Date: July 2, 2012

To: Urban Stormwater Workgroup and Expert Panels

From: Tom Schueler, CSN

Re: Resolution of Technical Issues Related to the
Urban Retrofit and Performance Standards Expert Panel
Recommendations

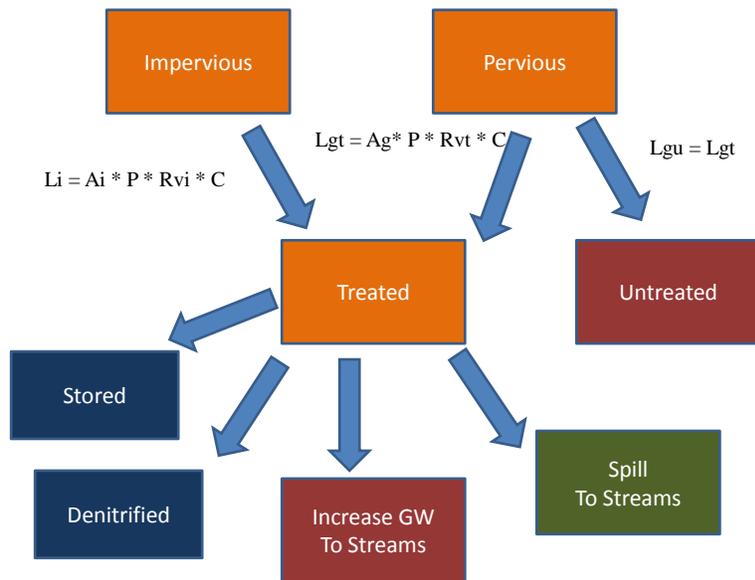
Issue: The adjustor curves are used to define a removal rate that applies to both the pervious and impervious areas in the contributing drainage areas for the stormwater treatment practices. The removal rates properly apply to surface runoff and some portion of the interflow delivered to the stream, but may not properly apply to groundwater export of nitrate-nitrogen from the urban landscape. The "missing" nitrate may reflect direct leaching of nitrate into groundwater in pervious areas that is not captured or treated by a down-gradient retrofit or BMP, or it may reflect nitrate that is exits a runoff reduction or stormwater treatment practice via infiltration into soil, or

slow release through an under drain (e.g., bioretention). See Figure 1 below:

If overland flow is diverted to groundwater, the overall load is reduced by using the ground as a filtering medium, but not eliminated. While ongoing research has indicated that it may be possible to enhance subsurface de-nitrification through certain design factors, we lack, as of now, definitive evidence for this effect.

Therefore, the WTWG concluded that current TN adjustor curves may over-estimate TN removal rates, and should be discounted to reflect the movement of untreated nitrate into streams, at the scale of the small watershed. This discounting is not needed for TKN, TP or TSS as these pollutants are not mobile in urban groundwater.

The proposed resolution is to develop a discount factor to the existing panel protocols to account for groundwater nitrate migration from runoff reduction practices.

Figure 2. Revised TN Adjustor Curve

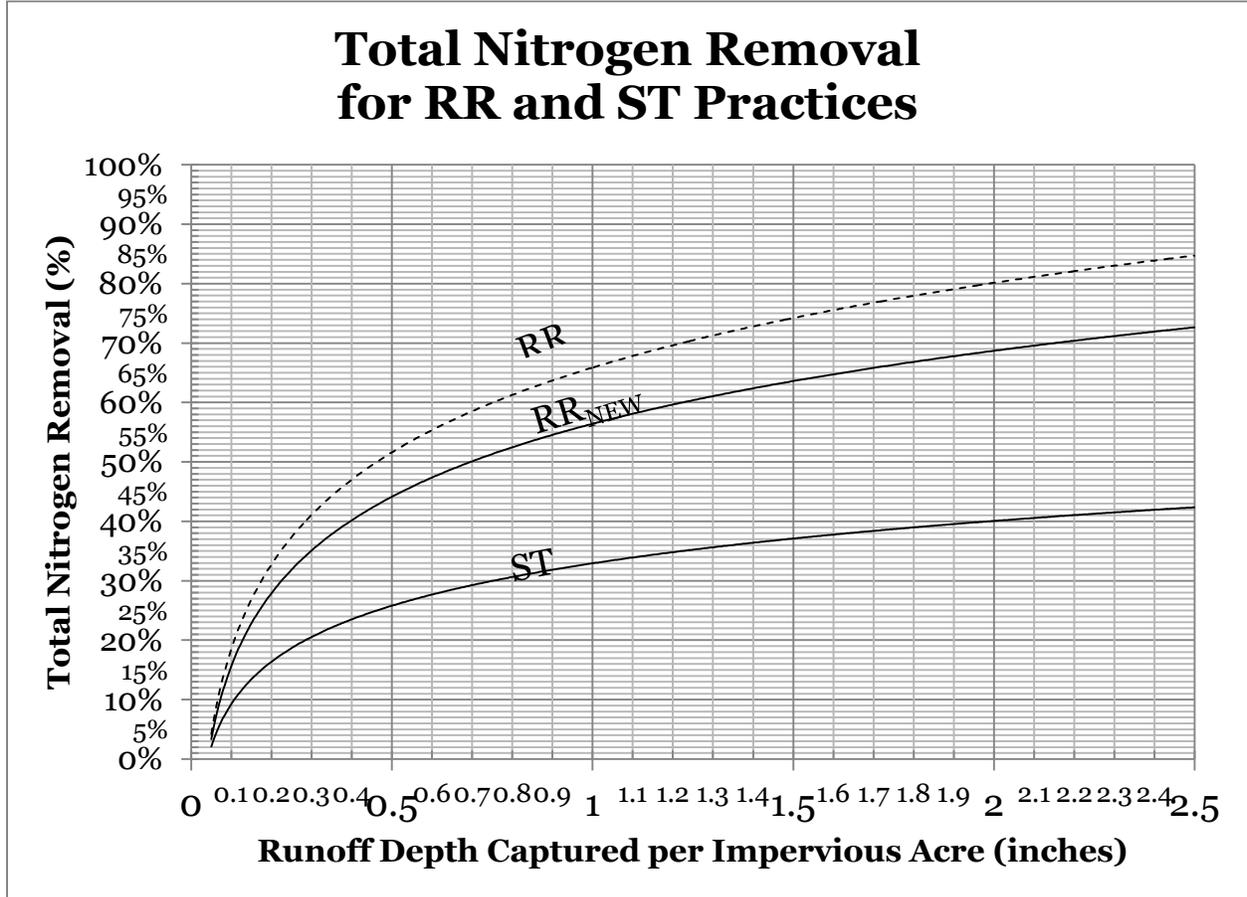
Therefore, it is recommended that maximum nitrate removal within runoff BMPs be assumed to be no more than 40%. Although this value may seem generous, it should be noted that some additional nitrate removal is likely after the nitrate exits the BMP and moves down-gradient through soils on the way to the stream.

Given the inflow concentrations, the potential groundwater/under drain nitrate loss would be $(0.3)(0.60) = 0.18$, or a discount factor of 0.82

The discount factor is then applied to the anchor rates used to derive a new N adjustor curve. The anchor rate for RR practices would be adjusted downward from the current 70% to 57%, and the existing runoff frequency spectrum equation would be used to develop a new, lower curve for TN removal. An example of the how this discount influences the existing N adjustor curve is shown in Figure 2.

Option 1 Action: The USWG supports the modified resolution as provided above, and that the revised N removal rate adjustor curve shown above replace the current one. Design examples would be modified accordingly, and the preceding technical discussion be added to the appropriate appendix that describes how the adjustor curves were derived.

Figure 3: Proposed reduction Multiplier for TN removal Rate based on % pervious area into the drainage area to a retrofit or a new stormwater BMP

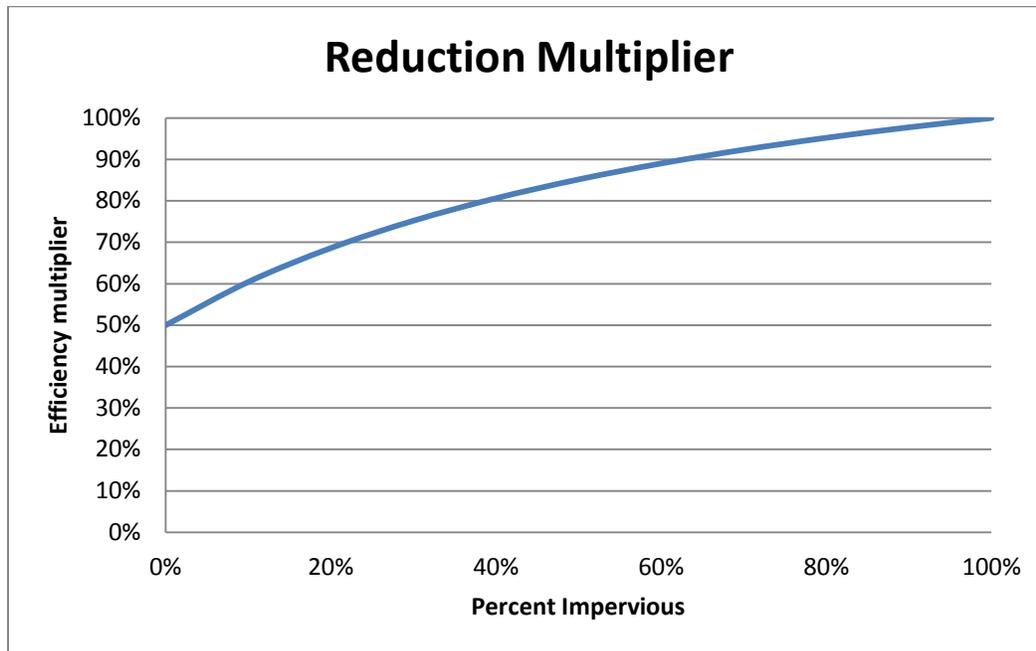
The 6/6/12 Schueler memo outlined a proposed "work around" method to account for groundwater nitrate loss from pervious areas that are not captured by BMPs (e.g., "escaped nitrate" that is not effectively captured by the BMP (i.e. because it infiltrates into soil (and into groundwater) up gradient of the BMP and effectively by-passes it OR it is nitrate is derived from another non-stormwater source and moves into the stream via groundwater down gradient of the BMP

Gary Shenk has proposed a simple method to define the untreated discounts based on runoff coefficients and urban hydrology. The nitrate load to the BMP treatment area (either RR or ST) is computed as the product of drainage area * precipitation * runoff coefficient * concentration.

As shown in Figure 3, the multiplier would be 1.0 for a practice with a 100% impervious drainage area, and 0.5 for a facility that is 100% pervious. This multiplier is then used to adjust the removal rate determined from the new TN adjustor curve.

Therefore, the user would use the following equations to adjust the TN removal rate obtained from Figure 2 to compute the final adjusted rate.

$$N_{adj} = RR_{NEW} \times (1 - P/2)$$

$$N_{adj} = ST \times (1 - P/2)$$

Figure 4: Baltimore County Stream Monitoring Data for Base flow Nitrate and Total Annual Nitrogen Loads (Stewart et al, 2005)

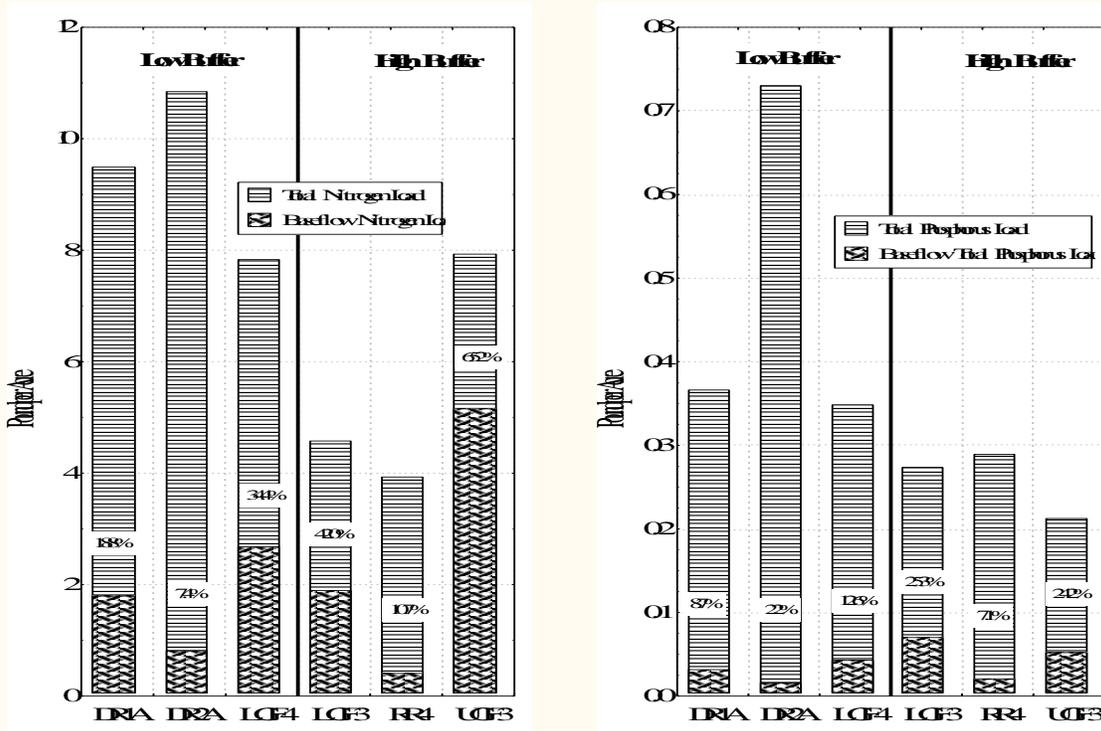
Some scientific corroboration of the Shenk modeling approach can be found in an analysis of urban stream nitrate loads taken from Baltimore county, which compare the ratio of base flow nitrate loads to total annual loads (See Figure 4, from Stewart et al, 2005)

If it conservatively assumed that all of the base flow nitrate monitored in urban streams represents untreated base flow, and the ratio of the annual base flow nitrate load to total annual stream total nitrogen load represents the discount factor. These watersheds are in the 25 to 50% IC range, so the average ratio of base flow nitrate to total nitrogen load

of around 20 to 30% is reasonably consistent with the Shenk multiplier equation (the one stream value of 54% is an outlier, and appears to reflect the impact of dry weather sewage discharges via illicit discharges and/or sanitary sewer overflows).
